Wireless Universal Serial Bus Specification Errata on Revision 1.0 as of December 2006

December 2006

Change: p87, Section 5.1, Figure 5-1 must look like:

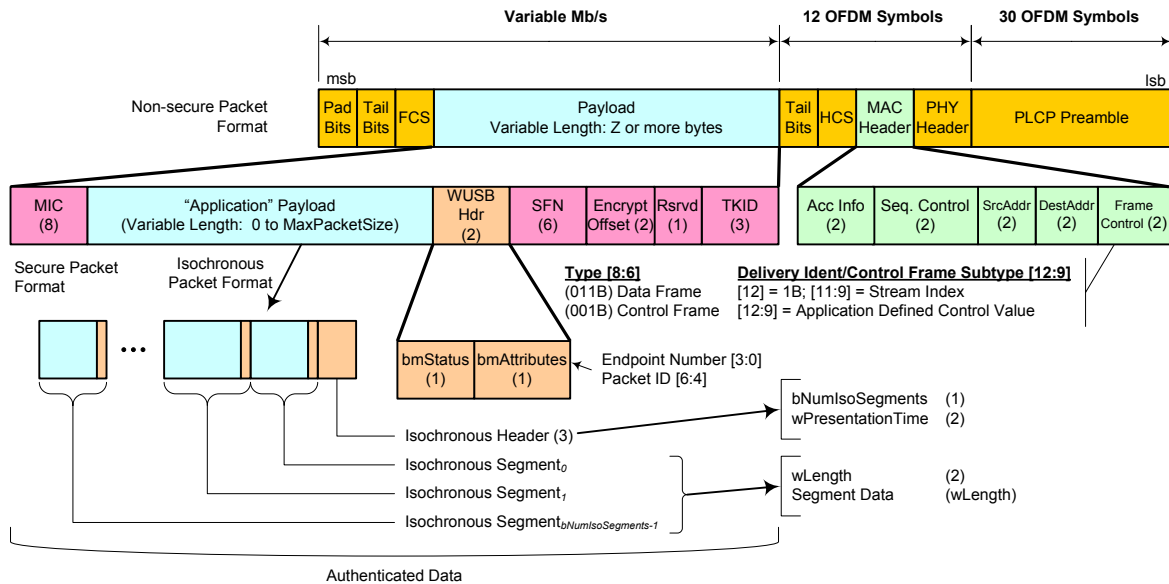
Erratum Title: Figure 5-1 incorrectly marks Authenticated data as “encrypted” data

Change: p137, Section 7.1, Figure 7-1 must look like:

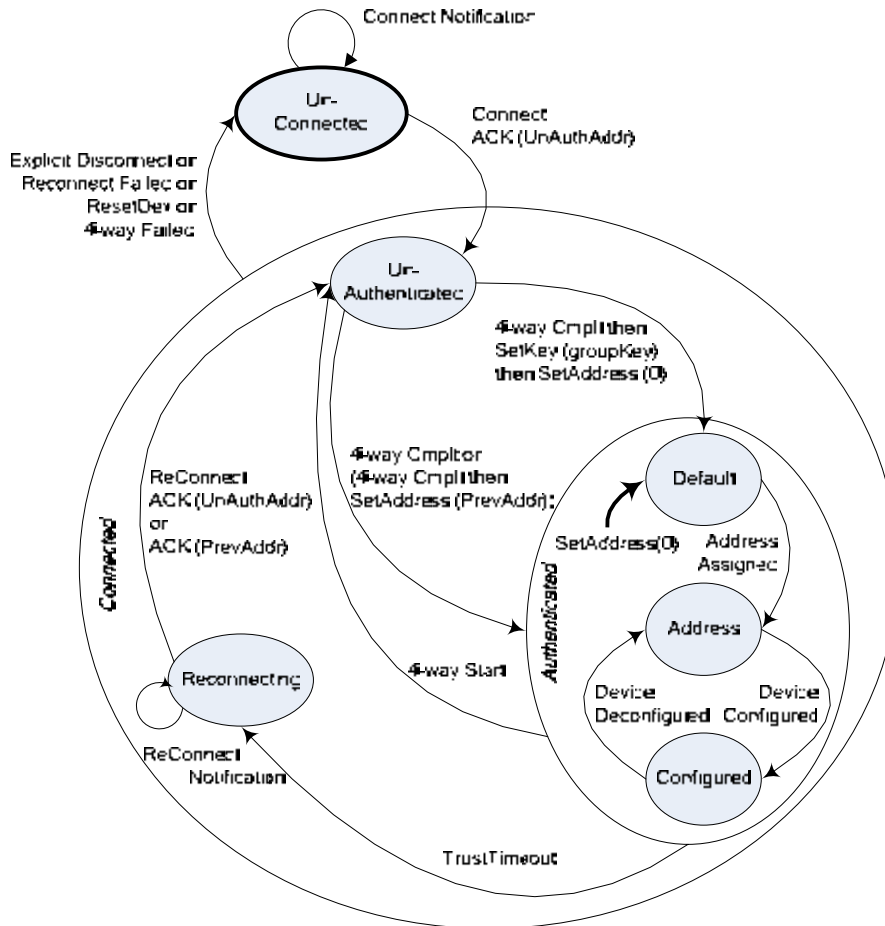
Erratum Title: Wireless USB Device States and 4-Way Handshakes.

Background: 4-Way handshakes are always performed in clear text (i.e. they are unencrypted) and a host may choose to re-authenticate a previously authenticated device at any time. However there is currently no state transition from the **Authenticated** state the **Un-Authenticated** state when a 4-way handshake is initiated.

Change: p139, Section 7.1.3, third paragraph must read as follows:

Note that the host may initiate a 4-way handshake at any time with the device, including while it is in any substate of the **Authenticated** device state. The control transfers used to conduct the 4-way handshake do not use secure data encapsulation during the data and handshake phases of the control transfers. A device must transition to the **UnAuthenticated** state when the host starts a 4-way handshake and all the keys the device has must be discarded.
